LANCASTER ESTATES SUBDIVISION

APPLICATION NUMBER 13 DATE February 20, 2014

REQUEST Subdivision

DETAIL SITE PLAN

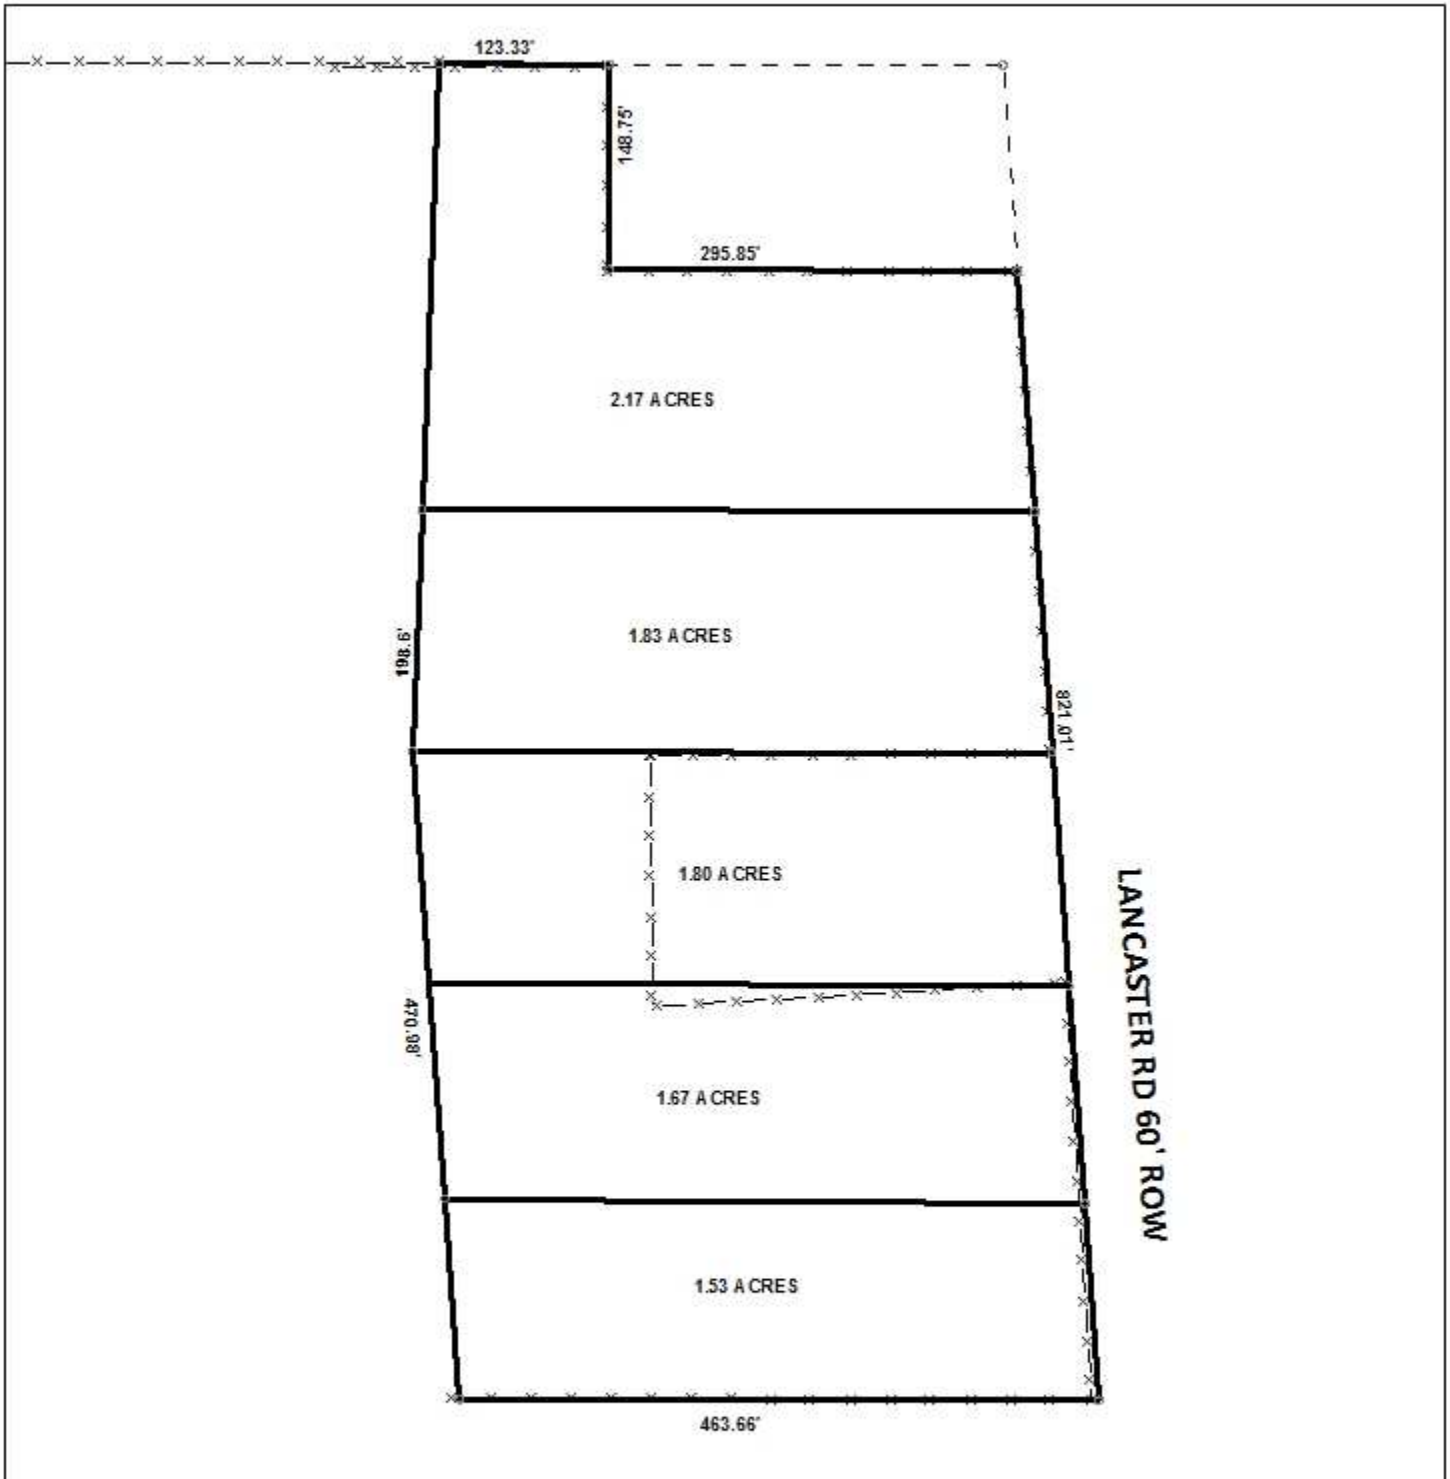
Each proposed lot will have a frontage width ranging from 143 ± to 175 ± feet along Lancaster Road, and will comply with the width to depth ratios of the Subdivision Regulations. The 25-foot minimum building setback line is not depicted, as required by Section V.D.9. of the Subdivision Regulations.

As each lot will have frontage widths less than 200 feet, they should be limited to one curb-cut each, with the size, design and location to be approved by Mobile County Engineering. A note on preliminary plat reflects this requirement, and should also appear on the final plat.

The preliminary plat does not label each lot with a number or letter. Thus the plat should be revised to label each lot so that it may be identified in a manner such as Lot 1 or Lot A of Lancaster Estates.

The northern-most proposed lot is “L”-shaped, however it does not meet the flag-shape lot criteria, in that the bulk of the lot fronts Lancaster Road. The odd shape of the lot is required in order to incorporate the entirety of the existing parcel, thus Section V.D.1. of the Subdivision Regulations should be waived

The lot size information on the preliminary plat is only depicted in acres, thus the plat should be revised to also include the lot size in square feet.

- 1) Revision of the plat to label each lot so that it may be identified in a manner such as Lot 1 or Lot A of Lancaster Estates;
- 2) Retaining of the note on the final plat stating that each lot is limited to one curb-cut, with the size, design and location to be approved by Mobile County Engineering;
- 3) Depiction and labeling of the 25-foot minimum building setback line;
- 4) Revision to include the size of each lot in square feet, in addition to acres; and
- 5) Retaining of notes on the final plat relating to endangered/threatened species, buffering of commercial development, and storm water compliance.
